DATE: January 13, 2021

<u>Certificate of Appropriateness Request:</u>	H-34-20
<u>Applicant:</u>	Betsy and Knox Morrison
<u>Location of subject property:</u>	108 Union St. N
<u>Staff Report prepared by:</u>	Katherine Godwin, Sr. Planner

Exhibit E

108 UNION STREET NORTH, CONCORD, NC

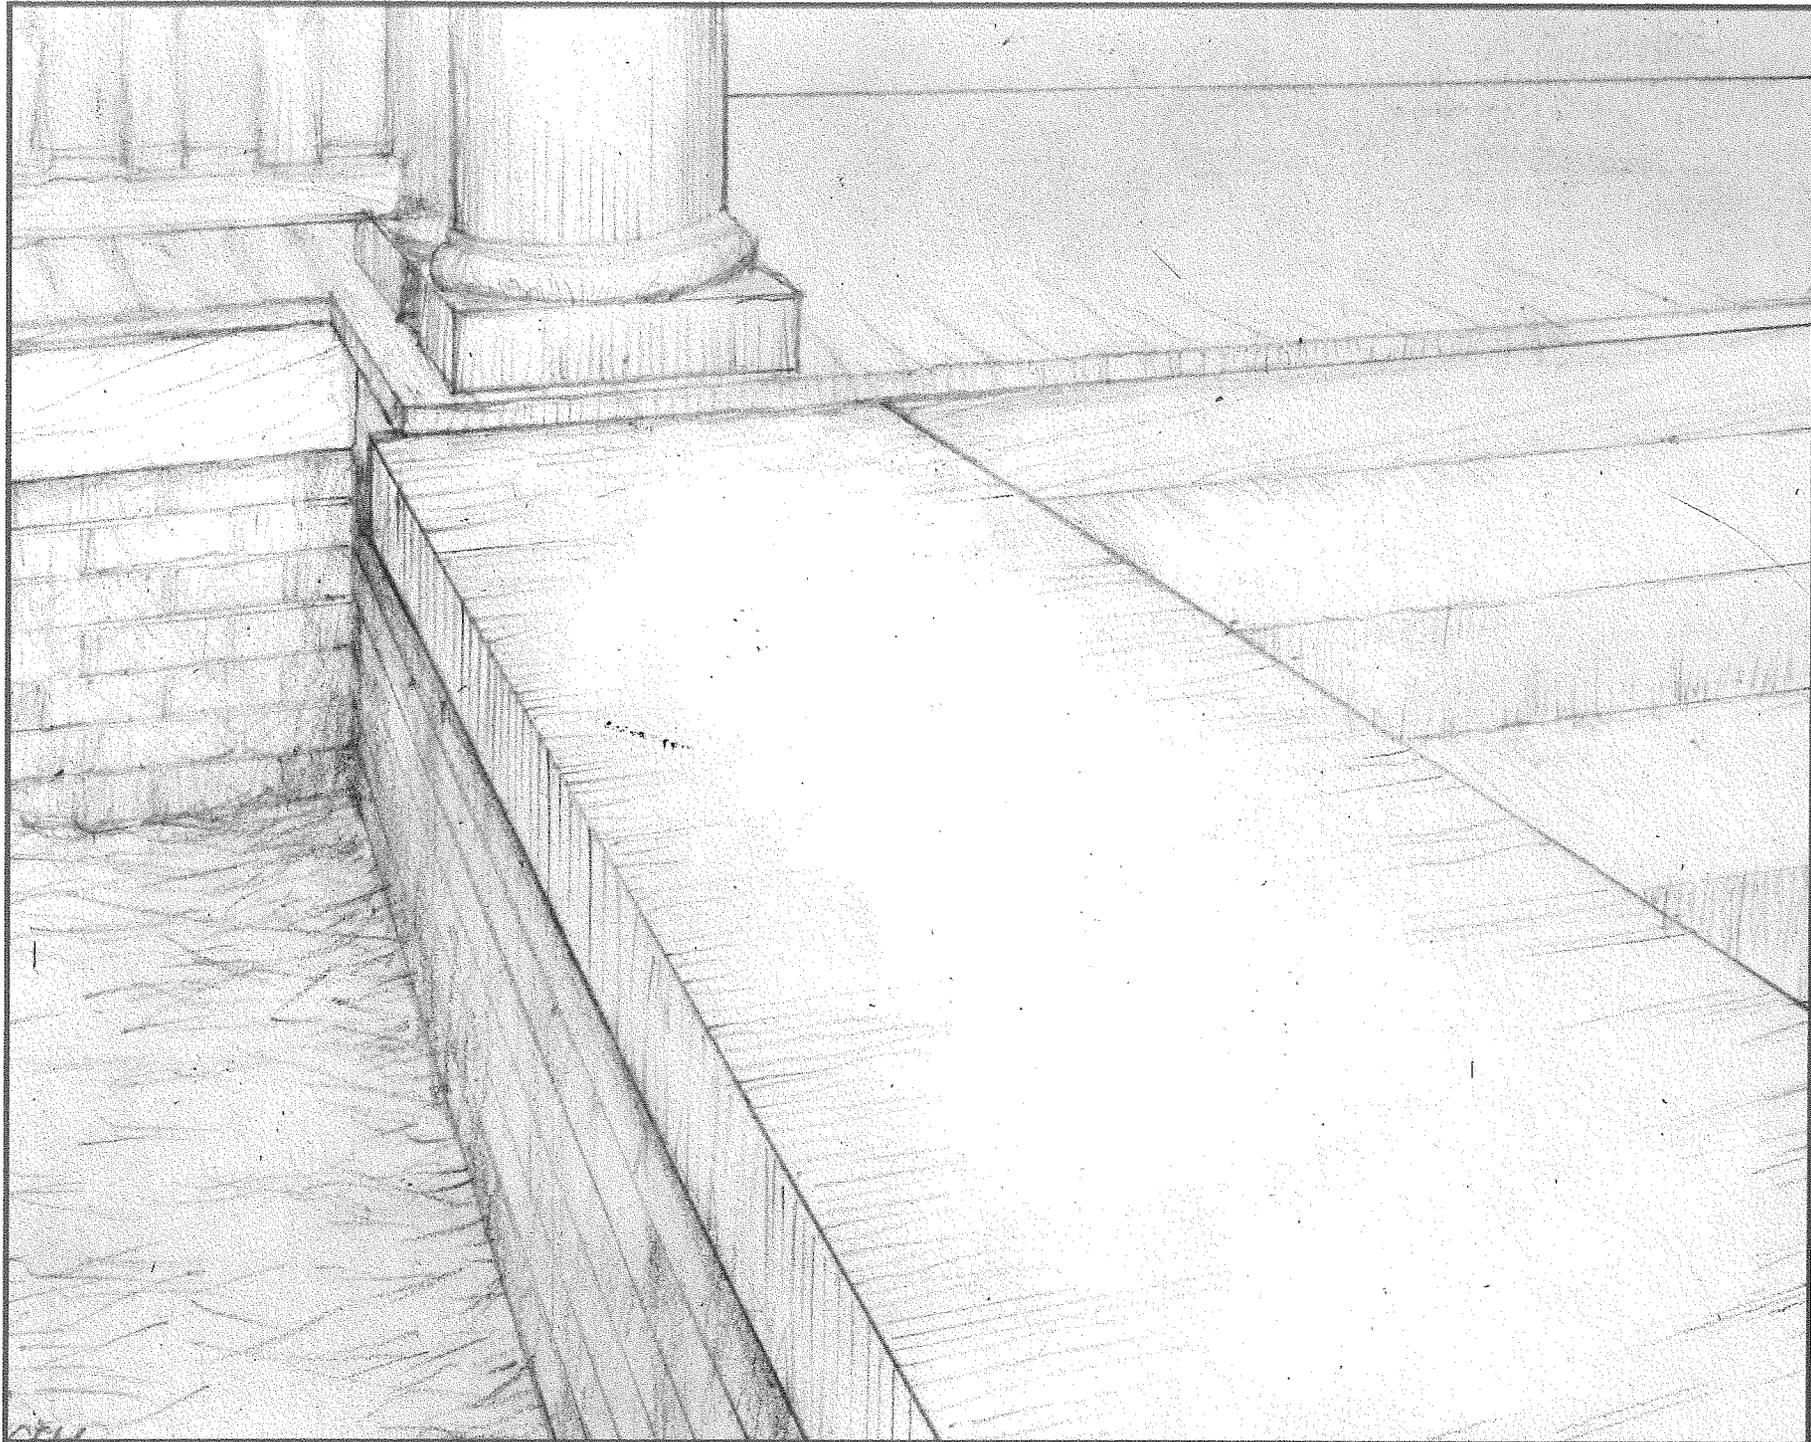
The applicants propose to replace the existing front porch stairs with wider and more uniform stairs, aligning the cheek walls and concrete caps with the center line of the adjacent columns and installing a handrail (Exhibits D and E). According to the applicants, the existing steps are a safety hazard with risers varying in height from 5 ½” to 8 ½” and treads varying in depth from 11 ½” to 13” (Exhibits E, E, and F). The new steps would have a uniform riser height of 7 ½” and a uniform tread depth of 11 ½” (Exhibit D and E). The width of the stairs would increase from 9’ 4” wide to approximately 11’ (Exhibit H). The existing steps have a parged finish atop of concrete masonry units (CMUs) (Exhibits D and F). The new steps would be parged with traditional concrete stucco atop a solid masonry core (Exhibits D and G).

I'm glad you were able to repair the columns and are planning on using the existing concrete caps if they can safely be removed in one piece. If I am interpreting your application correctly, the new handrail would be supported by steel bars- are these bars to be attached to the cheek walls/columns or be coming out perpendicular to the handrail from the stairs themselves? Ideally the handrail would not be attached to the wood column or the concrete caps that are historic materials. Preferably they would either be attached to the new cheek wall or supported by bars attached to the new stairs. Are either of these options amenable to you and if so which one would you like to propose?

I'm glad you were able to repair the columns and are planning on using the existing concrete caps if they can safely be removed in one piece. If I am interpreting your application correctly, the new handrail would be supported by steel bars- are these bars to be attached to the cheek walls/columns or be coming out perpendicular to the handrail from the stairs themselves? Ideally the handrail would not be attached to the wood column or the concrete caps that are historic materials. Preferably they would either be attached to the new cheek wall or supported by bars attached to the new stairs. Are either of these options amenable to you and if so which one would you like to propose?

The new handrail will be independent of the columns and cheekwall. It will be installed into the new masonry stairs.

ALIGNMENT OF CHEEK WALL w/ COL.

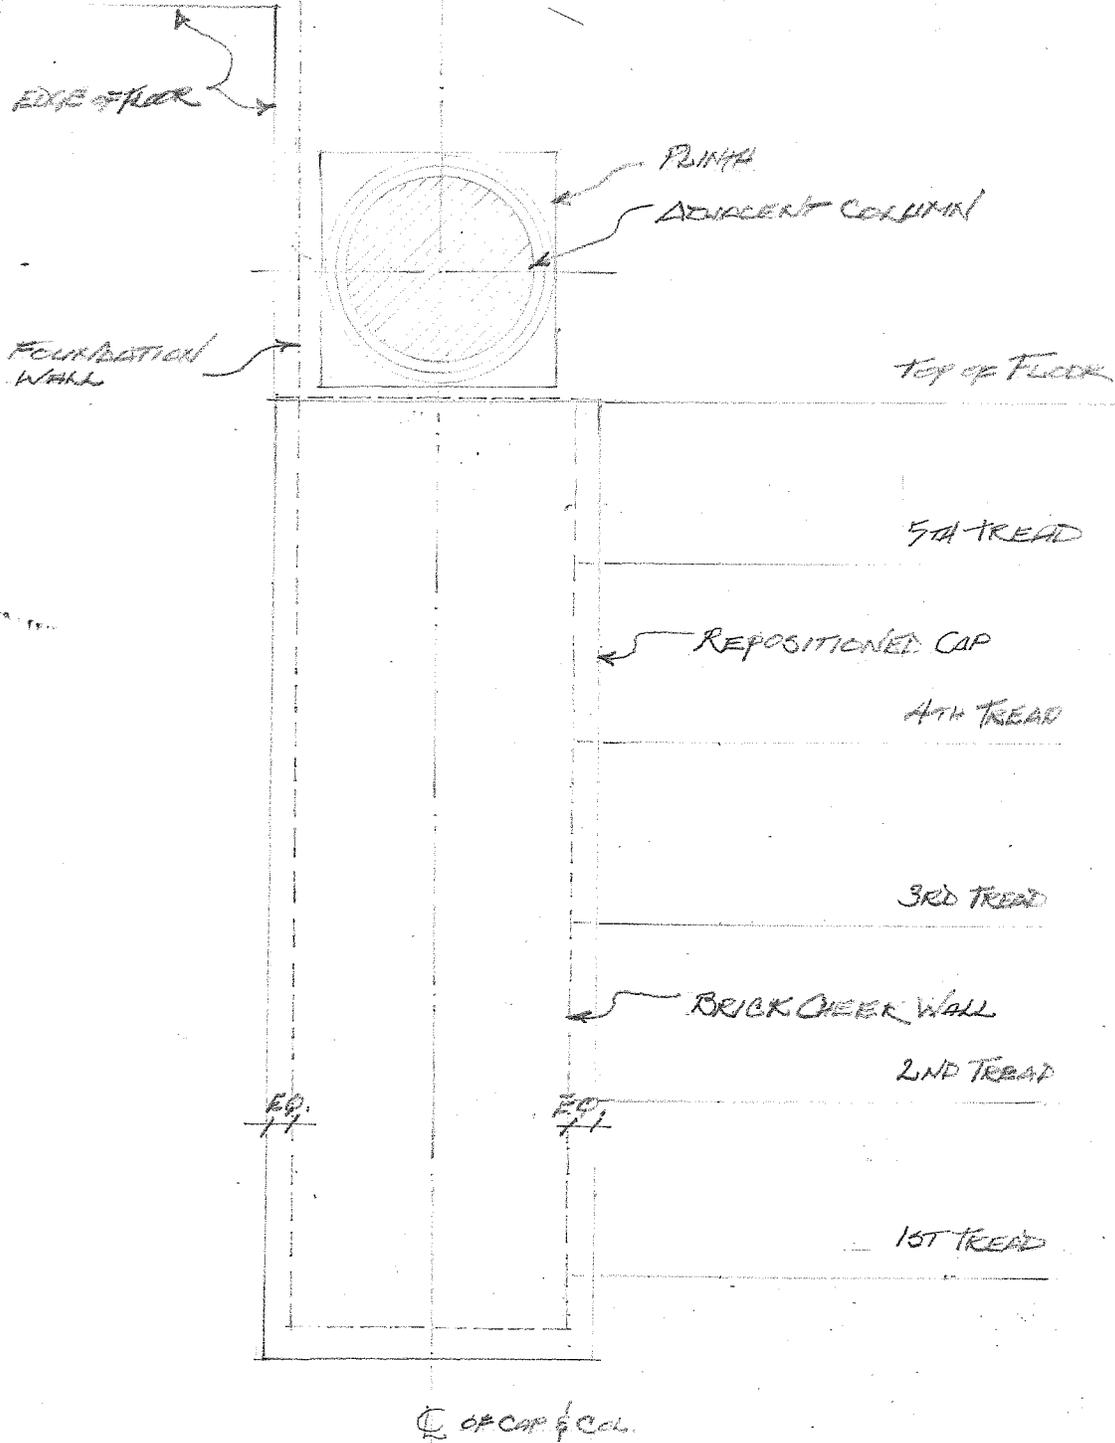
The two cheek walls would also be moved approximately 16" further apart and reconstructed to align with the two columns on the front porch (Exhibits D, E, and H). The cheek walls would be constructed of brick that matches the rest of the house as best as possible and topped with the existing concrete cap if it can safely be removed and reinstalled (Exhibits D, E, F, and G). The dimensions of the cheek walls would remain the same (Exhibits D and E).

What is the current width of the stairs (top and bottom tread)? What will the new width be (top and bottom tread)? In other words how far are you moving the brick cheek walls?

What is the current width of the stairs (top and bottom tread)? What will the new width be (top and bottom tread)? In other words how far are you moving the brick cheek walls?

The current width of the stairs is 9 feet, 4 inches (top & bottom tread). Upon completion, the width of the stairs will be approximately 11 feet (top & bottom tread). We plan to move the cheek walls out 16 inches total (so that they will center with our existing columns and provide the ability to build safe stairs).
